THE GLEN AT WIDEFIELD FILING NO. 12
RESIDENTIAL SUBDIVISION CONSTRUCTION DRAWINGS
PREPARED FOR WIDEFIELD INVESTMENT GROUP

EPC STORMWATER REVIEW COMMENTS
IN ORANGE BOXES WITH BLACK TEXT

Kiowa Project No. 19016
May 3rd, 2023

GLEN AT WIDEFIELD NO. 12
Plan and Profile - Golden Buffs Drive
Sta: 8+00 to 15+50
EL PASO, COUNTY, COLORADO

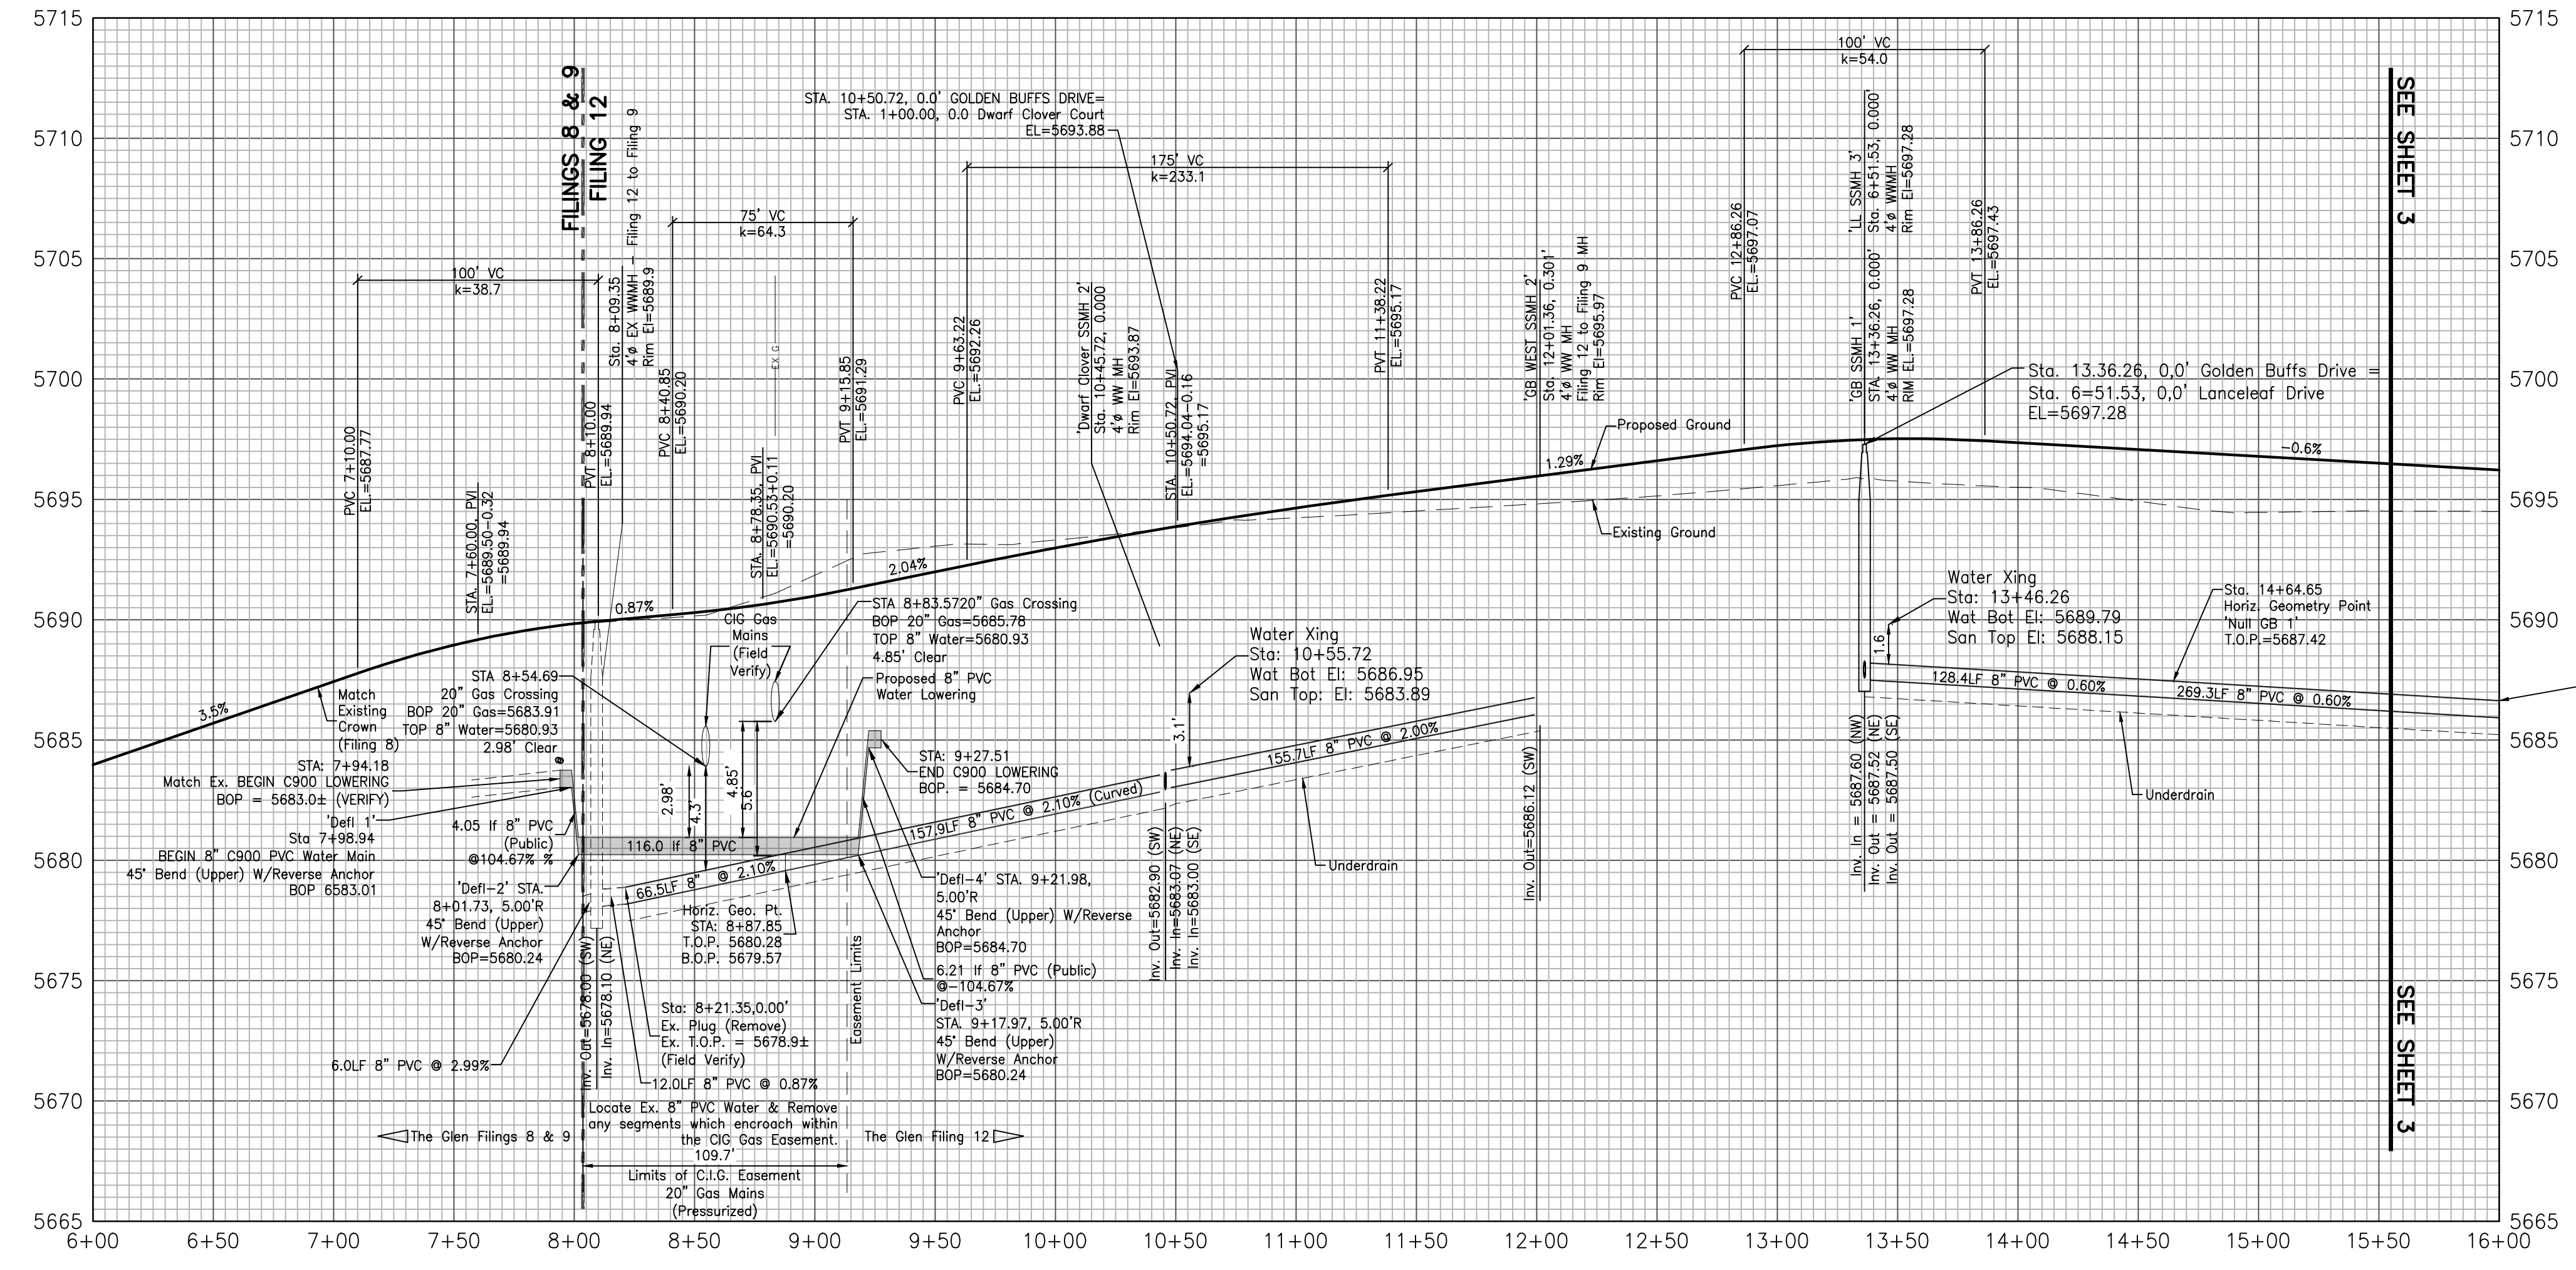
please remove as this is not County nomenclature for roadway classifications.

GLEN AT WIDEFIELD NO. 12
Plan and Profile - Golden Buffs Drive
Sta: 15+50 to END
EL PASO, COUNTY, COLORADO

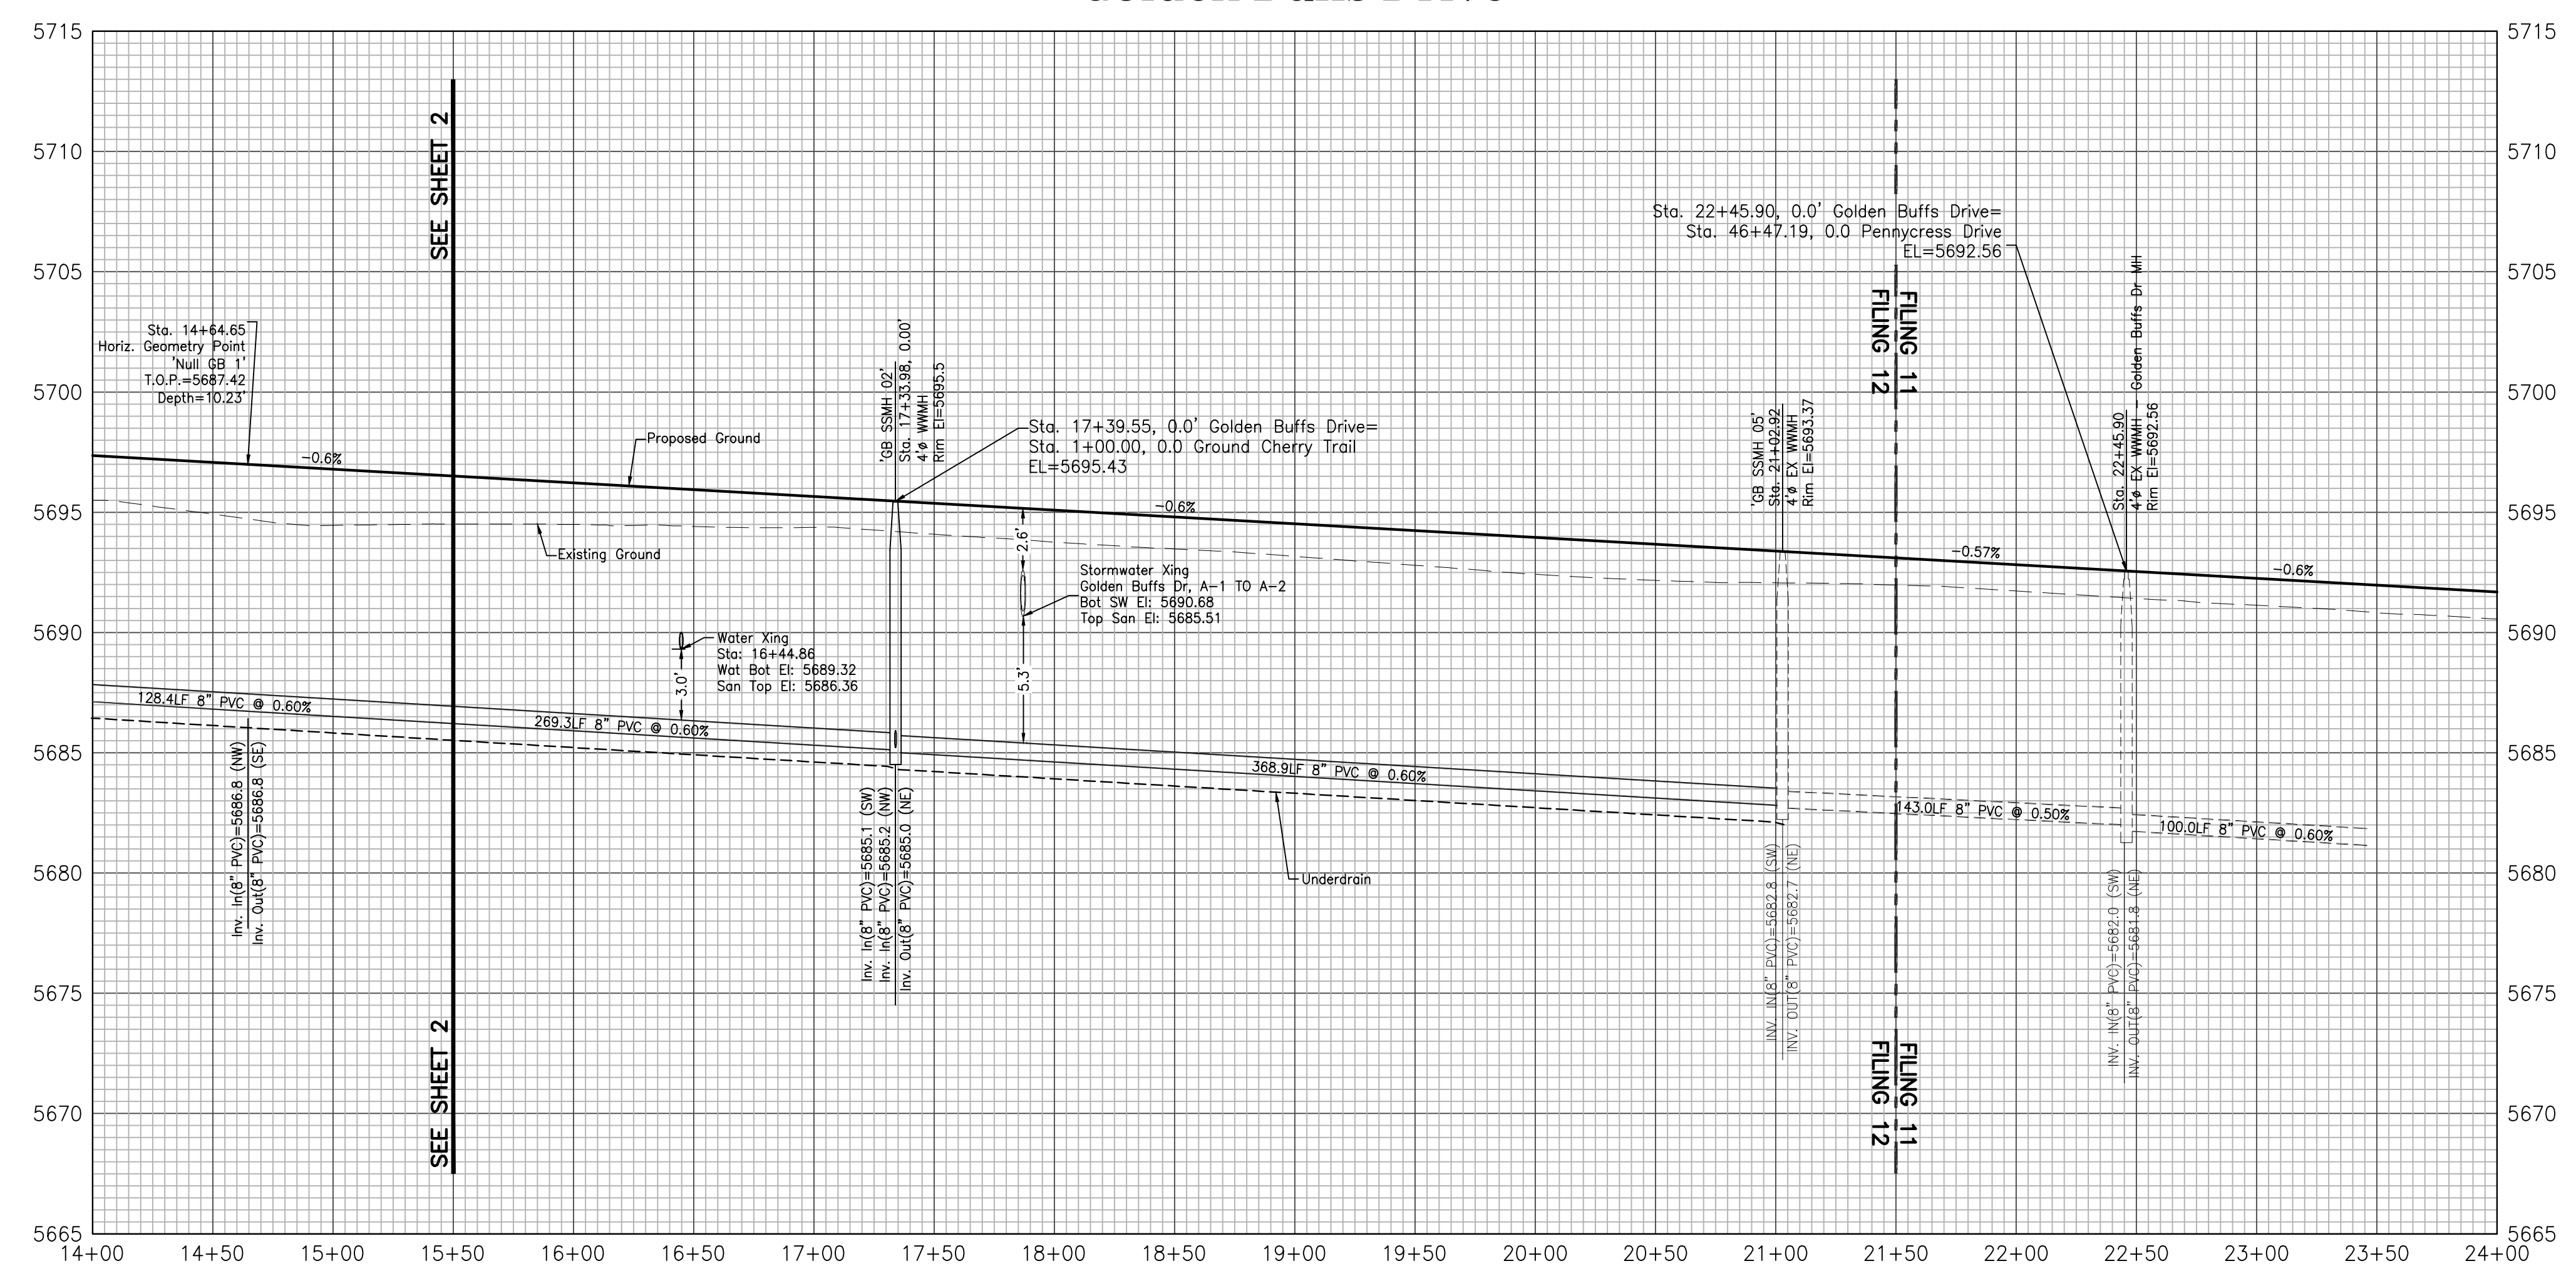
delete
Road Classification: Urban Local
Residential-Local Collector
Residential Design Speed=25 MPH
